Project :Flash_Remote_Receiver	File :
Sheet :	Editor : dg
Page 2 of 3	Company :
Date : 2011.10.29 Ver. : 2.31	Comment :

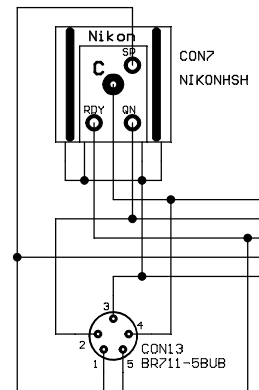
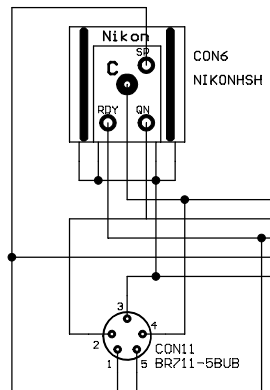
May not work because of gate threshold!

Levels at SP are:  
 1.0V or higher for wakeup level  
 0.5..0.8V for flash active level  
 This may not lie inside the MOSFETs gate threshold tolerances!
